**To:** Charlie Cazier, Intracoastal Engineering  
**From:** Nicole Smith Associate Planner; 910-341-1611  
**CC:** File;  
**Date:** 1/5/2021  
**Re:** Franklin Forest Ph. 2

Engineering has reviewed the plans for the Franklin Forest Phase 2 project submitted December 1, 2020 for TRC review and have the following comments:

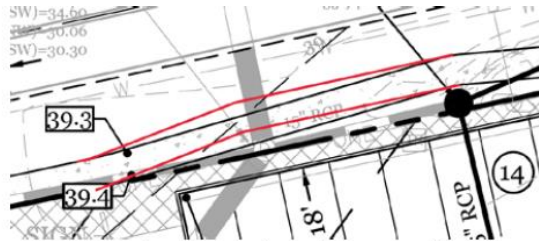
1. The proposed sidewalk along Franklin Avenue appears to end prior to the western property line. Please extend the sidewalk to the property line.
2. No further comments.

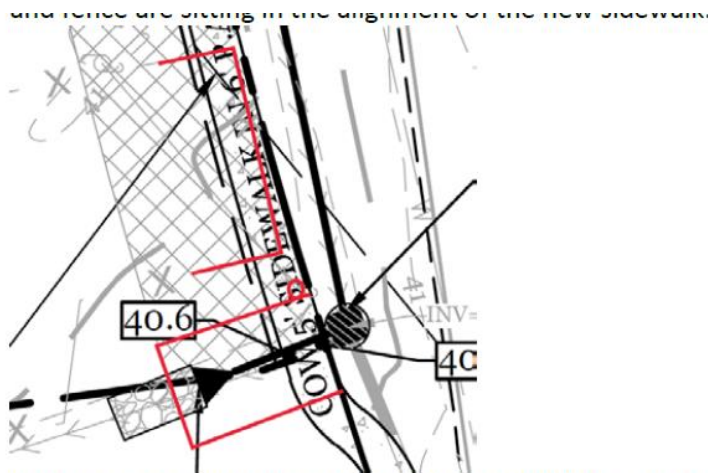
1. 10-year and 50-year HGL Calculations: Was a tailwater elevation assigned to the new Franklin Avenue system since it is adding runoff to the system and connecting to a large diameter pipe?
2. C-1:
  - a. Realign the sidewalk to keep the SDMH out of it. The sidewalk needs to be a minimum of 12 inches, preferably 18 inches, away from any MH lids, power poles, drop inlets, etc.

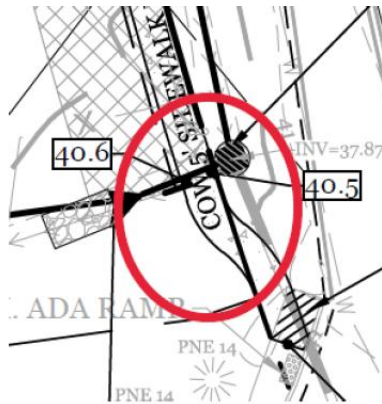
- b. The new 18" pipe needs to be in a public drainage easement. The existing power pole and fence are sitting in the alignment of the new sidewalk.

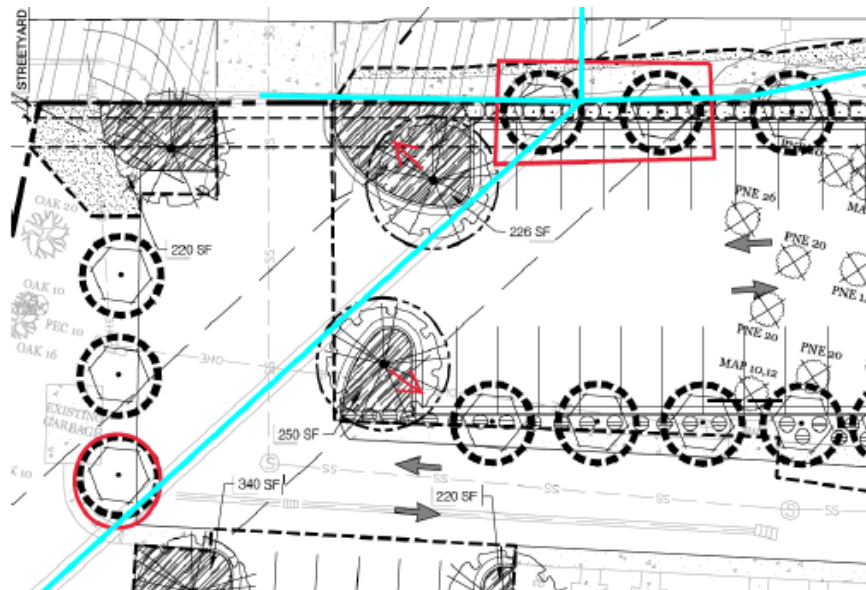
- c. Will there be a shallow swale over the new 18" pipe along Lullwater to direct runoff to DI #2?
- d. A portion of the new Lullwater sidewalk appears to be located outside of the public r/w and on the adjacent property. Relocate the sidewalk if the adjacent property owner has not agreed to this. The pipe and rip rap apron appear to be off the subject property as well.
